**TDI DIESEL GENERATOR**

**DESIGN REVIEW  
AND  
QUALITY REVALIDATION  
REPORT**

**SOUTHERN CALIFORNIA EDISON**

**SAN ONOFRE NUCLEAR GENERATING STATION**

AREA TO BE INSPECTED  
(“NE” Piston only)

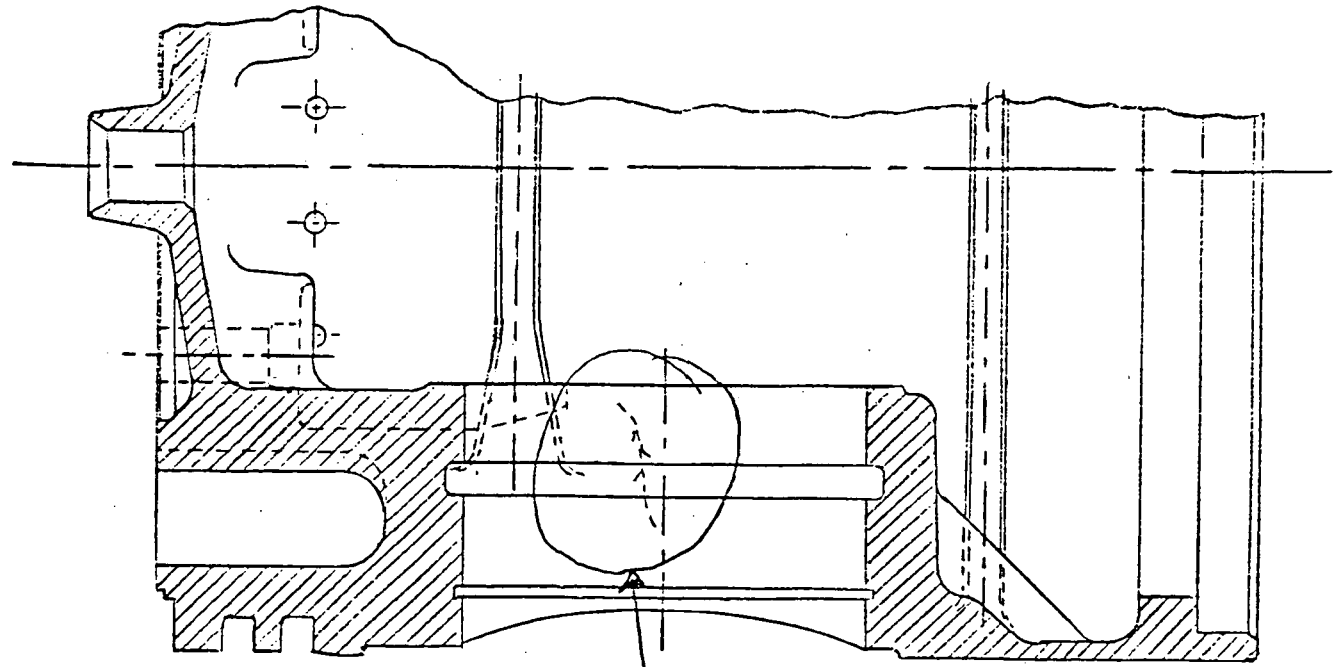
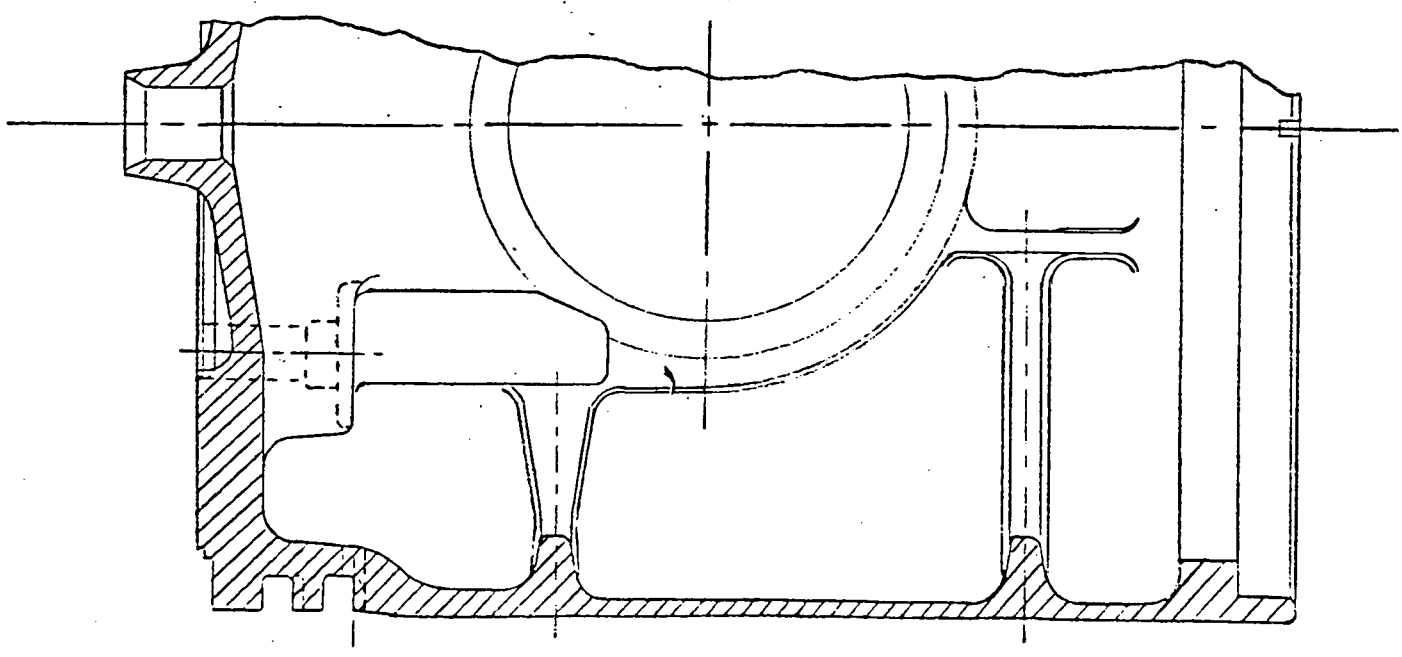
1. Assemble and review existing documentation.
2. Prior to installation, perform a Liquid Penetrant test on the piston skirts. Map all linear indications in the stud boss area and document with photographs. In addition, "AN" pistons should be inspected adjacent to the wrist pin boss.
3. If Liquid Penetrant test results from task #2 reveal indications greater than 1/32 inch length, one of the following tasks should be performed:
  - a) Remove the indications by surface conditioning; or
  - b) Perform an Eddy Current test to determine if the indications must be removed.
4. Perform a Liquid Penetrant test on the rib area near the wrist pin and on the rib at the intersection of the wrist pin boss to check for indications in the casting ("AE" pistons only). See attached sketch.
